DEVIATION REQUEST AND DECISION FORM

Project Name :	FLYING HORSE NORTH FILING NO. 5
Schedule No.(s) :	6136000005, 6136004037, 6136003004, 6136000003
Legal Description :	TWO TRACTS OF LAND WITHIN SECTIONS 30 & 31, TOWNSHIP 11 SOUTH, RANGE 65 WEST OF THE 6 TH PM

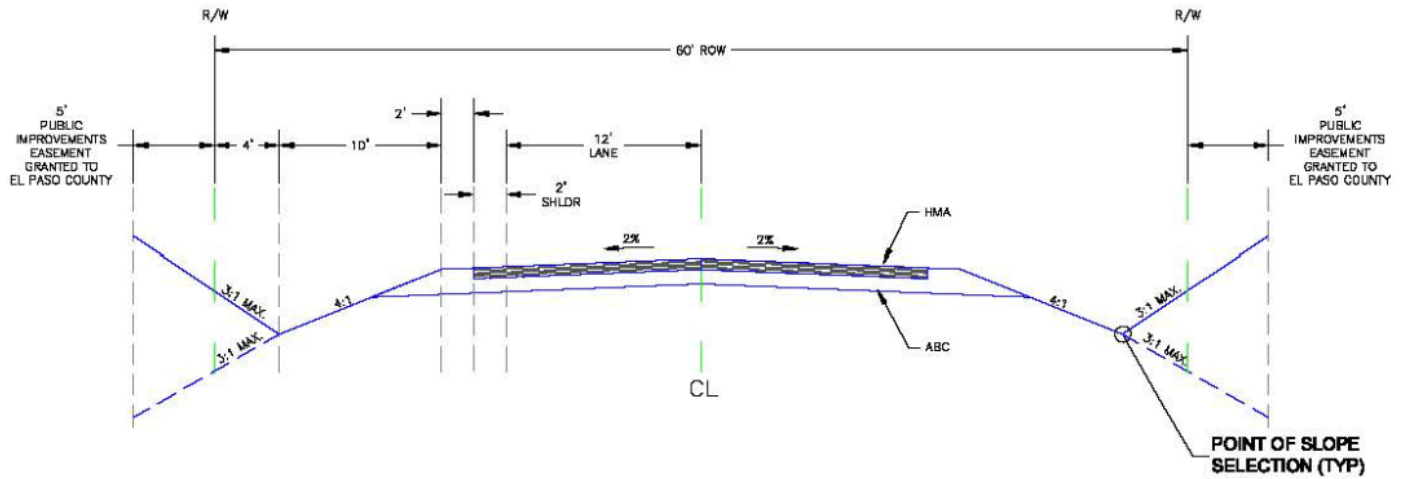
2.3.2 Design Standards by Function Classification, Table 2-7
Requested is a rural local roadway within a varied public right-of-way width (near 60') to accommodate a raised median. The roadway lanes are 12' in paved width with 2' gravel shoulders which deviates from the typical 14' paved width for a local rural roadway. The reduced lane width is sufficient for the slow traffic around the raised median containing 6" vertical curb Type B with a landscaped area reserved for a monument structure or statue within a licensed encroachment area.

The proposed median does not require a deviation per ECM 2.5.8. The reduced paved width does. sufficient justification has not been provided for the reduced paved width. Please revise the CD's and provide the 14' paved width per County standards
